# Site Accessibility Evaluation

## Johnson County Poor Farm

**4811 Melrose Ave  
Iowa City, IA 52246**

ADA Only

### Finding: 2

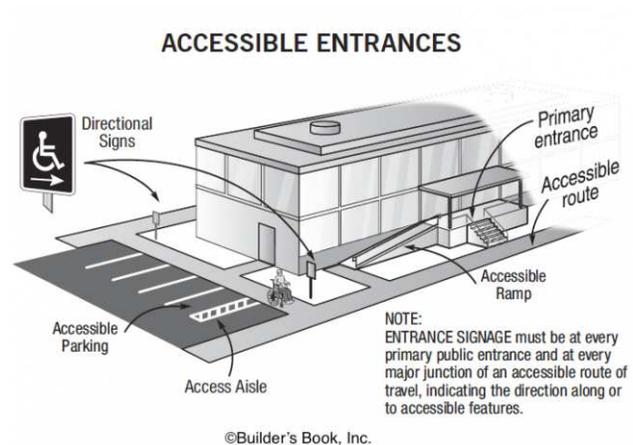
There is no accessible route between the buildings.

lacks routes from all buildings, grass impedes where small parking area is; CIL, loose gravel, and uneven surfaces leads to all buildings

Create AR with crushed and compacted stone or similar outdoor material from building to building within the site

### Finding: 3

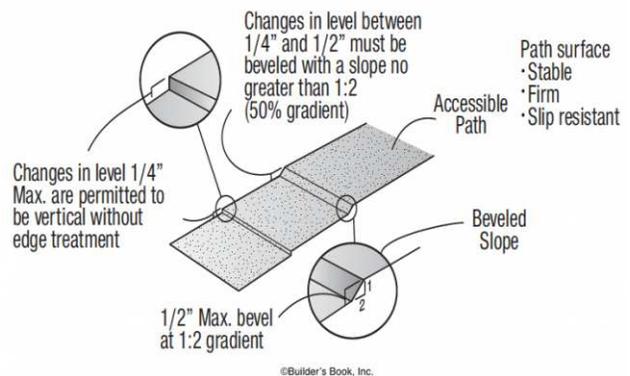
The accessible route contains loose gravel and/or surfaces that do not provide for a stable, firm slip resistant surface.

asylum parking- old  
deteriorated where  
people park for entry

Resurface AR where deterioration occurs

### Finding: 8

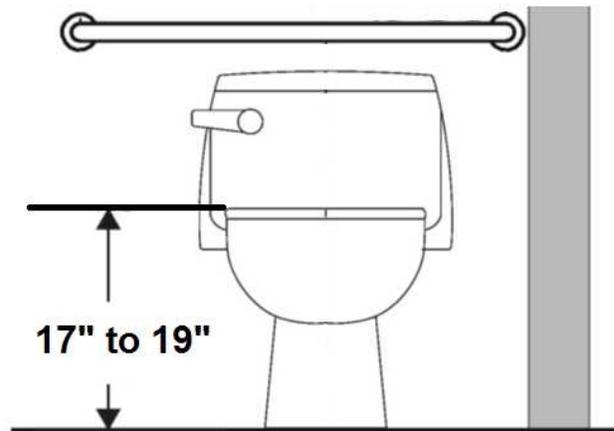
The toilet seat is not located within the range allowed off the floor.

19" seat height;  
centerline and grab  
bars compliant

Replace toilet seat, or re-set or replace toilet to 17" to 19" aff

### Finding: 9

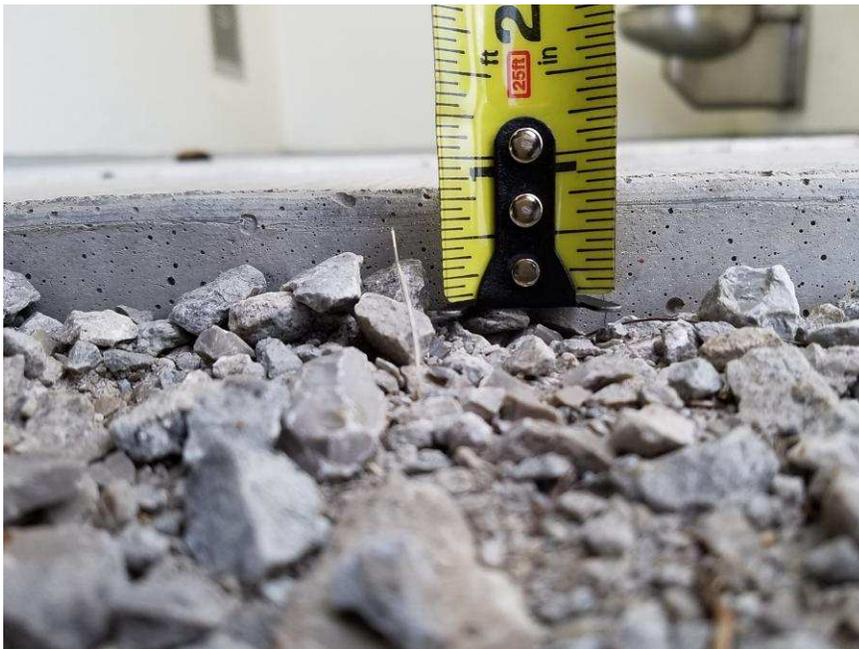
Minimum maneuvering clearances at doors and gates shall comply with 404.2.4. Maneuvering clearances shall extend the full width of the doorway and the required latch side or hinge side clearance.

CIL in MC of 1", 10#

For all doors along the public circulation route, provide required maneuvering clearance on push and pull side of doors

For all doors along the public circulation route, inspect, adjust, and maintain 8.5 lbf to open exterior doors as a smart practice

### Finding: 14

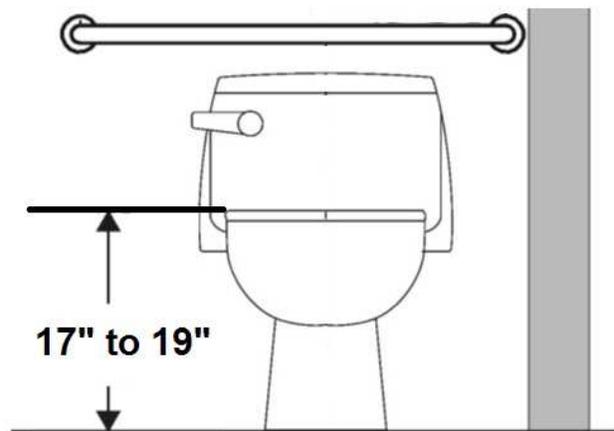
The toilet seat is not located within the range allowed off the floor.

19.5" to seat;  
centerline and grab  
bars comply

Replace toilet seat, or re-set or replace toilet to 17" to 19" aff

### Finding: 15

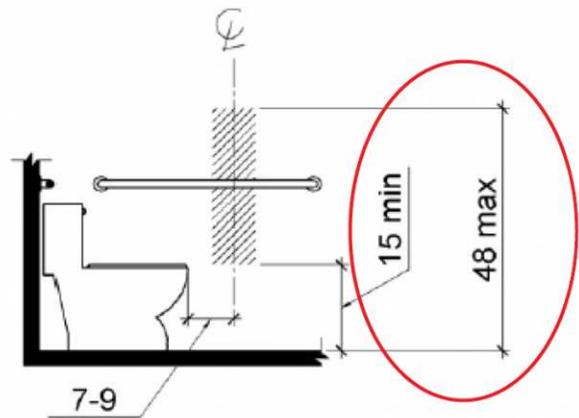
The toilet paper is not installed within the compliant range.

toilet paper dispenser  
is too far

Remount toilet paper dispenser max 7" to 9" from front of toilet, 15" to 48" aff and min 12" above or 1.5" below grab bar

### Finding: 16

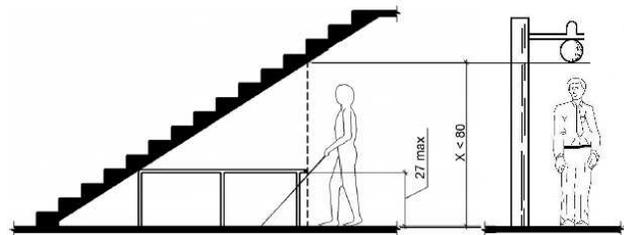
The overhead support extends down too close to the route of travel.

70.75" into cells

Raise support to min 80", or pad object to prevent hazard in overhead clearance along AR

### Finding: 17

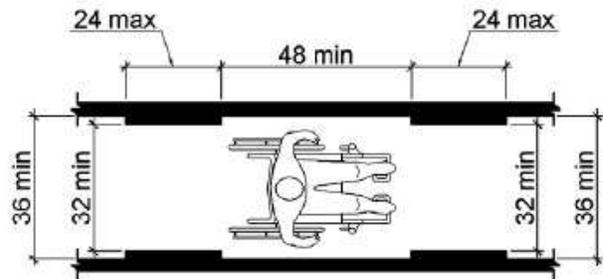
The route of travel at this location does not provide a minimum width of 36 inches.

24" into cells in  
asylum

Widen AR to compliant 36" clear width

### Finding: 20

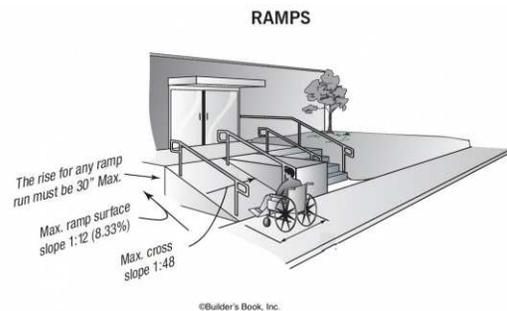
The ramps slope exceeds the maximum running slope (direction of travel) allowable of 8.33%.

11.6% slope on ramp  
to back asylum entry

Correct slope of ramp to max 8.33%

### Finding: 21

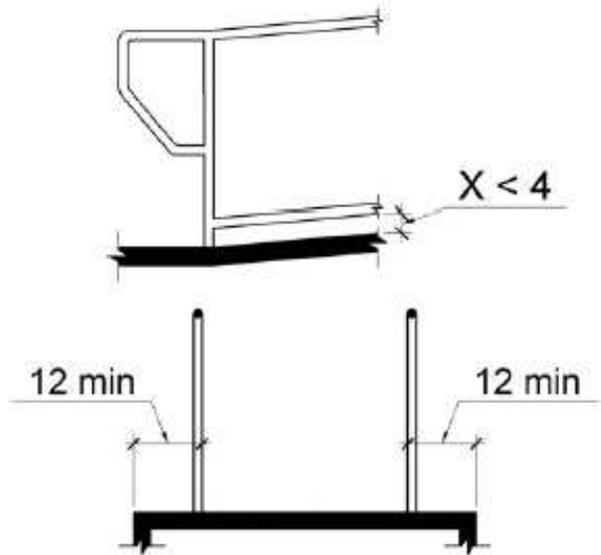
The ramp run has not been provided with edge protection.

ramp lacks edge protection

Install rail along bottom edge of ramp that prevents a 4" sphere from passing through

## Finding: 23

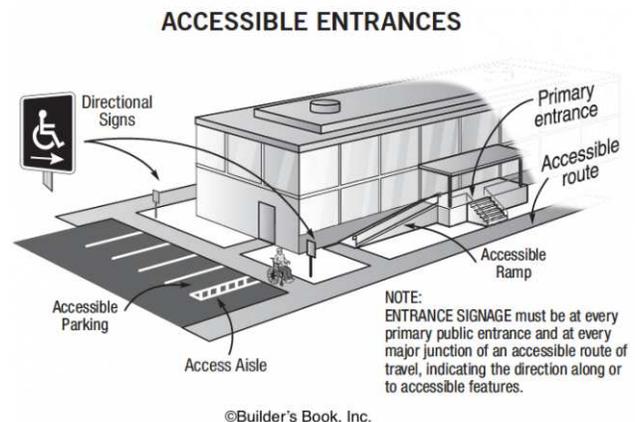
There is no accessible route to the gardens.

gardens- grass, small greenhouse that is going to be revamped/torn down

Create an accessible route with crushed stone or other outdoor material from parking or walkway to community gardens.
